Hurricane Planning Commission Meeting Agenda

June 13, 2024

Agenda Date:	06/13/2024
Application Number:	PSP24-11
Type of Application:	Preliminary Site Plan Application
Action Type:	Administrative
Applicant:	Wasatch Trailer Sales-Todd Campbell
Agent:	Karl Rasmussen
Request:	Approval of a Preliminary Site Plan
Location:	250 N Foothills Canyon Dr
Zoning:	GC PDO
General Plan Map:	Planned Community
Recommendation:	Approve subject to staff and JUC comments
Report Prepared by:	Fred Resch III

Agenda Date:	06/13/2024
Application Number:	PSP24-12
Type of Application:	Preliminary Site Plan Application
Action Type:	Administrative
Applicant:	Stratton Land Holdings
Agent:	Chase Stratton
Request:	Approval of a Preliminary Site Plan
Location:	765 W State St
Zoning:	HC
General Plan Map:	Commercial
Recommendation:	(See recommendation in body of report.)
Report Prepared by:	Fred Resch III/Gary Cupp

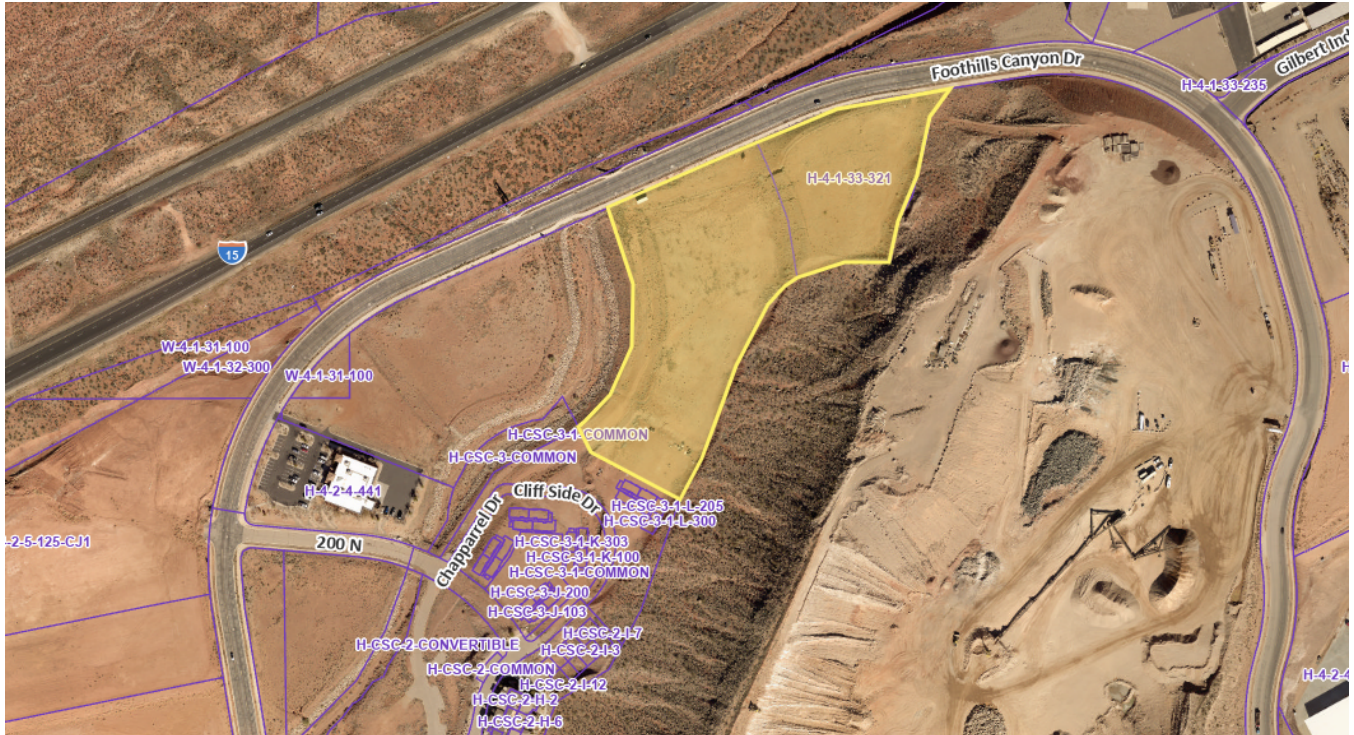
1. **Public Works:** Site drainage must be considered with this project. On site fire protection may be required due to the depth of the lot.
2. **Power:** Power is located on the north side of the Foothills Canyon Rd. A trench or bore will be necessary. Developer shall communicate with Hurricane Power before plans are submitted to fill out an application and to provide all information needed on power service sizing. Hurricane Power will design the power. All transformer loss fees and invoices will be paid before completing the project. Transformers have long lead times, the faster the info is given, the more likely the equipment can get to the project on time.
3. **Water:** Okay.

4. **Street:** No comments
5. **Sewer:** No comment
6. **Engineering:** Engineering recommends approval of the preliminary site plan. Significant changes aren't anticipated. Proposed accesses must be constructed with curb returns and eight-foot waterways (HCC 10-35-4(B)(2)). Do the "temporary restrooms" require water or sewer? It appears there are three (3) proposed parcels (one of which is landlocked). Engineering would encourage the applicant to merge the parcels with the existing parcel, H-4-1-33-321, when the additional area is obtained from the State of Utah because identifying, surveying, and conveying the appropriate cross access, public utility, and shared utility easements is cumbersome. The storm drainage swale needs to be directed to an acceptable outlet. It cannot discharge to the existing building (visit HCS 3.4.7.1(3rd paragraph)). Proposed water should connect to the existing water stub.

7. **Fire:** Need to provide distance from hydrant to building. Road to turnaround width must be 20' all weather service. 26' if hydrant.
8. **Phone:** No comment

23 parking stalls are proposed. An 11,465 sq ft office and service center and a 720 sq ft “temporary office” which would require 48 parking stalls total with at least 3 in the temporary phase. Information has not been provided to staff on the number of vehicles that will be displayed. Due to the large size of the parcels, staff is confident that the required parking can be adequately provided, which will need to be shown on the final site plan. Sufficient parking will also need to be provided on the temporary site.

- a. A full landscape plan will be required with the final site plan. The applicant will need to ensure enough trees and shrubs will be provided. Required trees and shrubs along Foothills Canyon Road can be provided in the existing parkstrip.

- 5. As noted above, there are currently two properties shown on this site plan, one of which is owned by the State of Utah. How exactly this will be handled, whether through subdivision or other processes will need to be resolved before final site plan approval.*

Recommendation: The Planning Commission should review this application based on standards within the Hurricane City Code. Staff recommends approval of the preliminary site plan subject to JUC and staff comments.

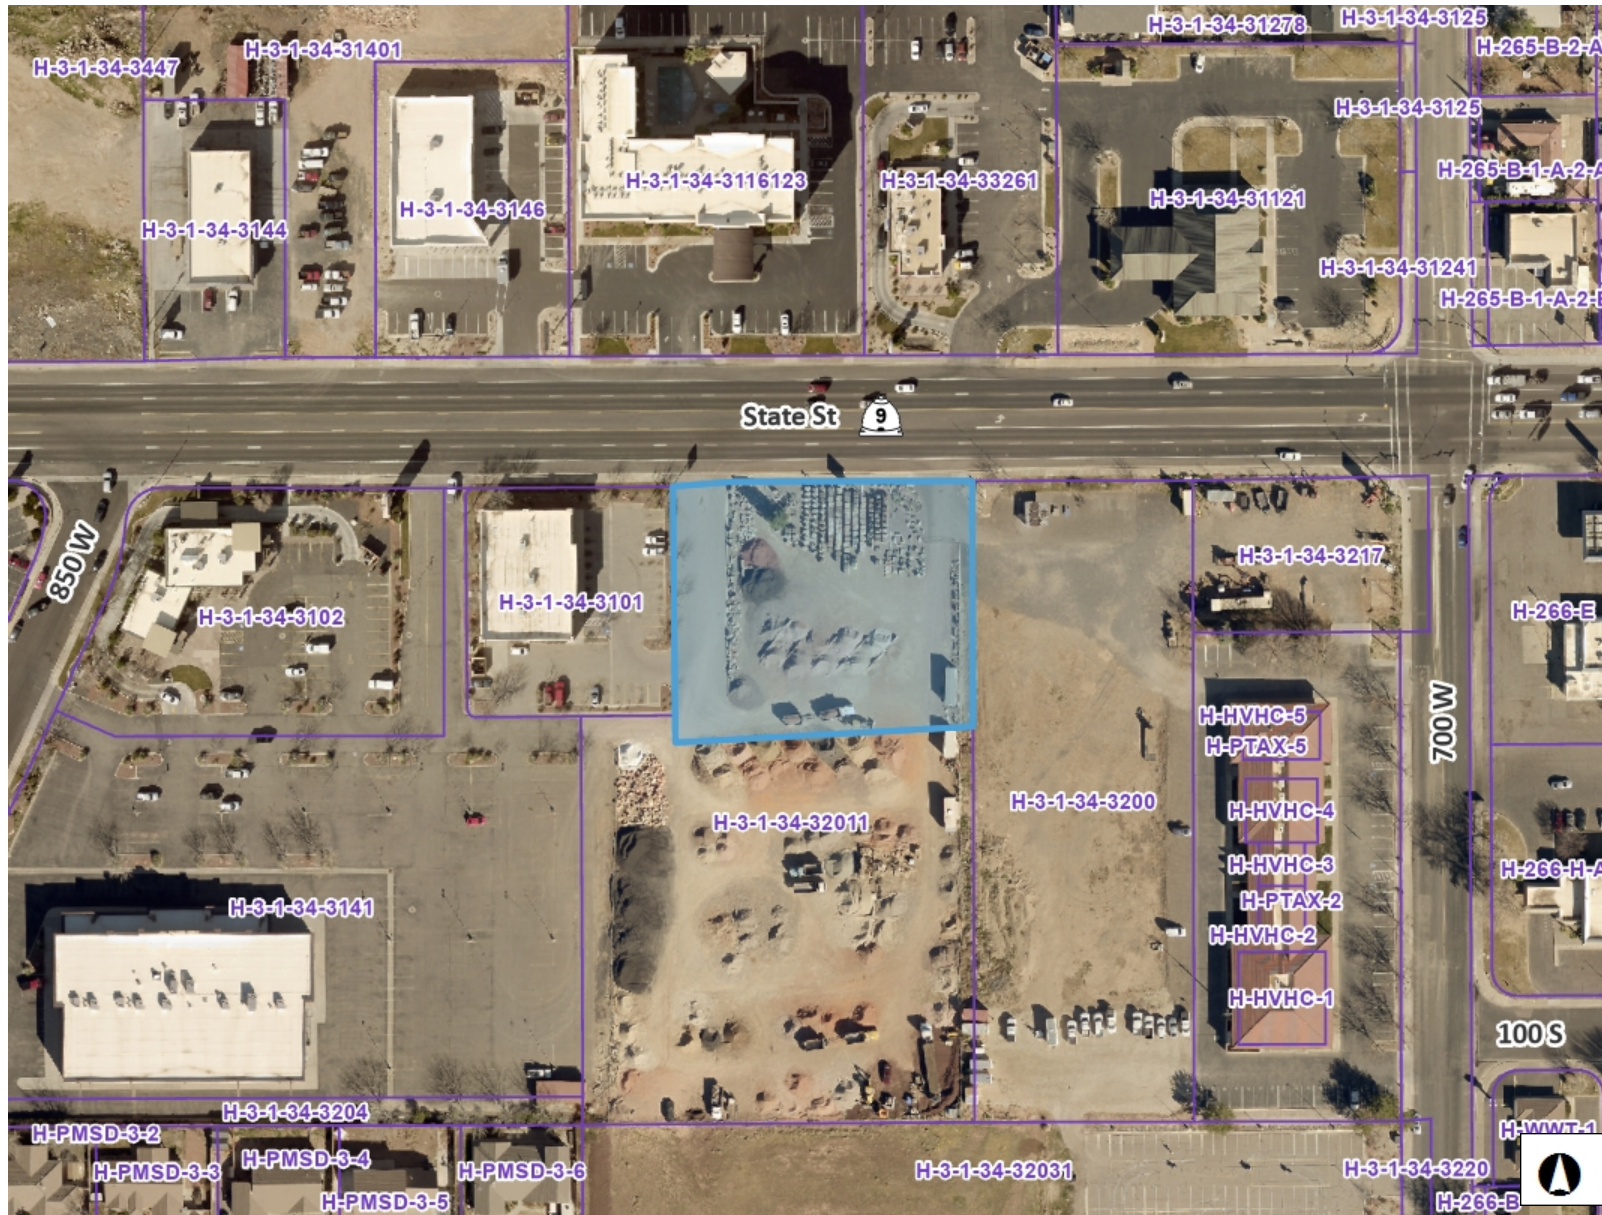
1. **Public Works:** We should be fully cognizant of the traffic situation on SR-9. Project needs to make every attempt to provide safe ingress-egress.

6. **Engineering:** Engineering does not recommend approving this preliminary site plan as is. Engineering instead recommends that the applicant is given time to investigate traffic needs of

the shared accesses and parking and time to update the layout per hurricane city standards and traffic recommendations. Cross access, shared utility, and public utility easements should be considered carefully as property lines are adjusted or created. Parcels can be unintentionally separated from necessary infrastructure (e.g. access to public street [HCC 10-34-8(B)]). It appears stormwater detention required by HCS 3.4.7 can be provided below the parking lot; however, the preliminary site plan does not specify where detention will be provided (HCC 10-7-10(D)(2)(a)(5)). Setbacks from the existing 24"ø sanitary sewer and 72"ø storm drain (City's maps show the sd pipe is 60"ø) should be formalized by easement. Throat length, the length of the area where turning movements in a driveway are restricted, is unacceptable (Hurricane Transportation Master Plan 9.3.7 (pg. 110)). Minimum throat length is specified by the anticipated queuing length for leaving vehicles. The applicant should obtain the anticipated queuing length by consulting a traffic engineer. "Driveways shall be aligned opposite each other wherever possible" Hurricane Transportation Master Plan 9.3.10 (pg. 112) (see also HCC 10-33-4(A)) The striping & signage/traffic control plan must be expanded to include the adjoining state street accesses (see HCS 3.2.7, see also HCC 10-33-4) and a complete paving/surfacing plan (see HCC 10-34-8(I)(1)) should be included to fully depict the site's proposed access and traffic circulation patterns plan (HCC 10-7-10(D)(2)(a)(4)). The applicant should ensure that the other sites can continue or connect to the proposed pedestrian path. HCC 10-33-5(H) specifies that, "a network of convenient, safe, and raised or textured pedestrian paths shall connect areas within the project, and should also connect the project to adjacent properties and transit facilities."

They are proposing 27 parking spots which meets this code for a 2,459 sq ft building. They will need to provide a minimum of one ADA van parking area. Room for stacking for five spaces appears to be provided.

3. Landscape: Hurricane City Code requires that a landscape buffer of 10’ wide shall front each right-of-way. The site plan does show this area has been provided.

4. Access: The site plan proposes site access from the existing driveways for Del Taco and O'Reilly's. Engineering has concerns about number and placement of the accesses on those driveways.

Recommendation: Staff recommends the Planning Commission review this application based on standards within the Hurricane City Code. Staff has requested an updated exhibit addressing the engineering department's comments, and at the time of this writing, the requested exhibit had not been received. Staff recommends that the Planning Commission table this item pending receipt of the updated exhibit. Should the updated information be submitted prior to the 6/13/24 meeting, staff would support approval of the preliminary site plan.

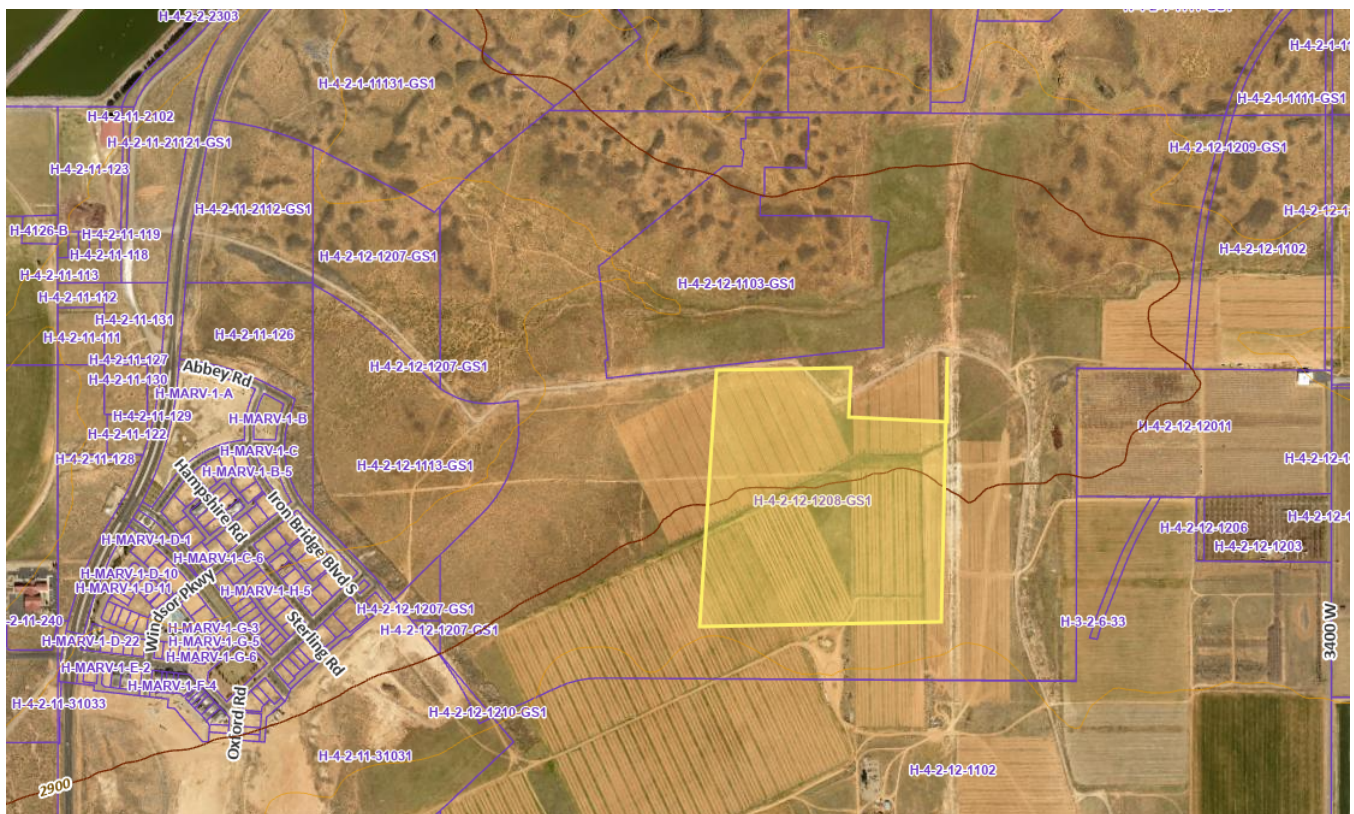
1. **Public Works:** This project is dependent on the PID infrastructure in Bash Parkway and Gateway Blvd. The owner needs to provide a copy of the contract between them and the PID showing a time and date specific for the completion of the PID infrastructure. Need to show how they plan to accomplish a second access with the PID roads being incomplete. It appears that Gateway Blvd needs to be complete of utility looping and access.
2. **Power:** Dixie Power area. No comments received.
3. **Sewer:** No comment
4. **Streets:** No comment
5. **Water:** Culinary water lines will need to be looped.

6. **Engineer:** Additional review needs to be done on the construction drawings. Good to proceed with the preliminary plat.
7. **Fire:** Hydrant spacing according to 2021 IFC.
8. **Cable/Phone:** Good
9. **Gas:** Good
10. **Water Conservancy District:** Please add our notes to the plan set. Washington County Water Conservancy District hereby acknowledges that based on the information provided, the zone change adequately mitigates interference with district facilities and property interests. The District reserves the right to rescind this acknowledgement if additional information becomes available. The district has not determined whether water will be available for this development and does not hereby make any guarantee of water availability. In addition, the development must conform with applicable district requirements, including but not limited to payment of fees.

4. Subdivision improvement plans for phase 1 and 2 have been submitted as required by HCC 10-39-8.
 - a. Comments specific to the construction drawings have been sent to the applicant.

8. A will serve letter from Hurricane City Water and Ash Creek Sewer District has been provided
9. Utilities: The property is isolated but has services planned for the area. The PID has submitted plans to bring services to the site and there are existing unpaved roadways to the site. Hurricane City Code states the following:

Recommendation: Staff recommends the Planning Commission review this application based on standards with Hurricane City Code. Any approval of the application should have the following conditions.
